Service Bulletin

Bulletin No.: 20-NA-220

Subject: Rear Camera Inoperable

Brand:	Model:	Model Year:		VIN:		Engine:	Transmission:
		from	to	from	to		
Chevrolet	Silverado 2500/ 3500 HD	2021	2021				
GMC	Sierra 2500/3500 HD

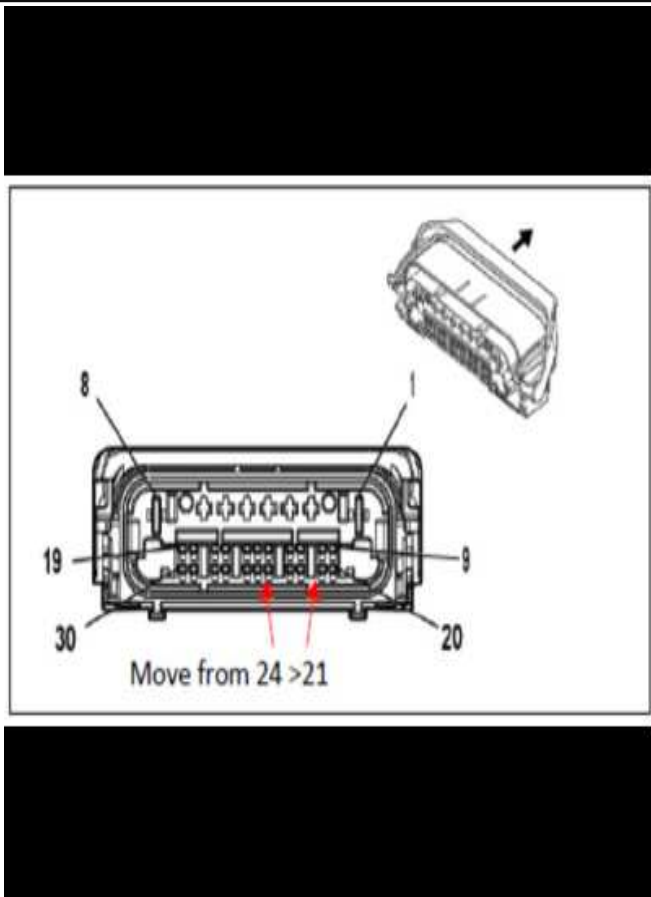
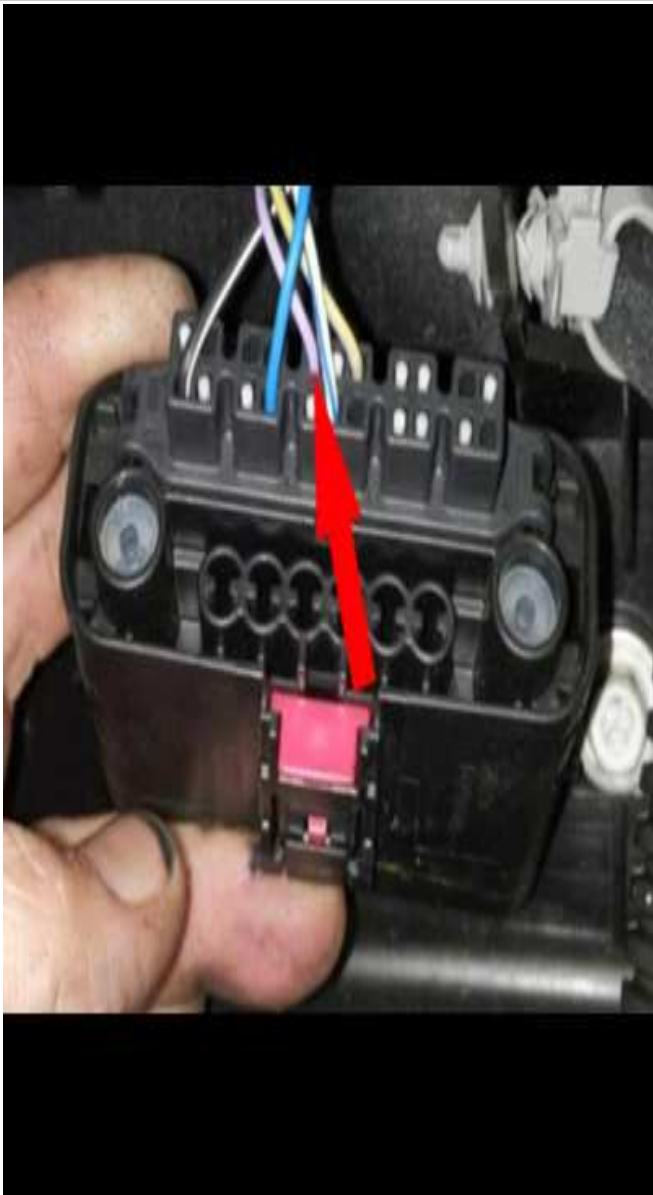
Involved Region or Country	
Additional Options (RPOs)	Equipped with RPOs 5N5 & ZW9 Rear Camera
Condition	Some customers may comment on the rear camera being inoperative.
Cause	<p>The cause of the condition may be that a change was implemented to the chassis harness from 2020 to 2021 trucks, there was an issue with camera flicker and circuit 1739 was moved from pin 24 to pin 21.</p> <p>The camera extension harness P/N 84852714 in the 5N5 Rearview Camera kit was not updated to correspond to the change in the chassis harness. This mis-match leaves the camera inoperative when installed by the dealer or upfitter and as such stalls the delivery to the end customer.</p>
Correction	Move wire from pin 24 to 21 of the terminal in the Rear Camera Harness. Refer to <i>Repairing Connector Terminals (Terminal Repair)</i> in SI.

Wire connected to Pin 24

Wire moved to Pin 21

Labor Operation	Description	Labor Time
*5480928	Move wire in pin 24 to pin 21	0.2 hr
*This is a unique Labor Operation for Bulletin use only.
